Subject: Rotary New Control Box

Please be noted that Rotary Lift vehicle lifts manufactured in VSGA have undergone upgrade and will be supplied with revised control box for Australia, SEA and India markets from November 2019 production. Please be noted that the ATO77 was changed during August 2019 production.

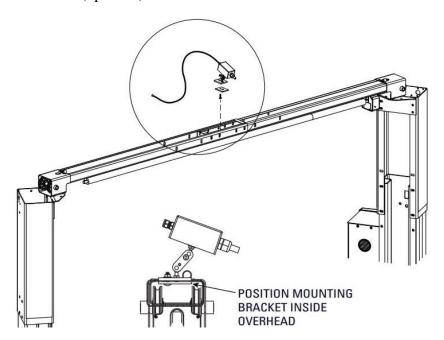
The addition of the new switch box will allow the accessories of **SPOTLINE LASER** and **LOCKLIGHT** to become plug and play. The new features give the customer flexibility to choose the accessories at time of installation or after once the lift is installed.

Included in the installation kit of the lift, there is literature titled Manual FA9147Y Series Control Box. Within the manual, there is installation and wiring detail supporting the new product. Please note, the change of control boxes will not affect the specifications or performance of the lift, however the new FA9147Y-UL-12 control box requires the electrical supply to be 5 wire including natural.

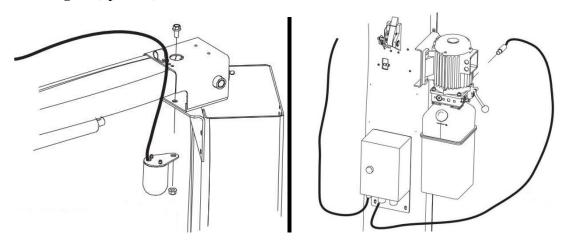
Laser Kit: (optional)

Lock Light: (optional)
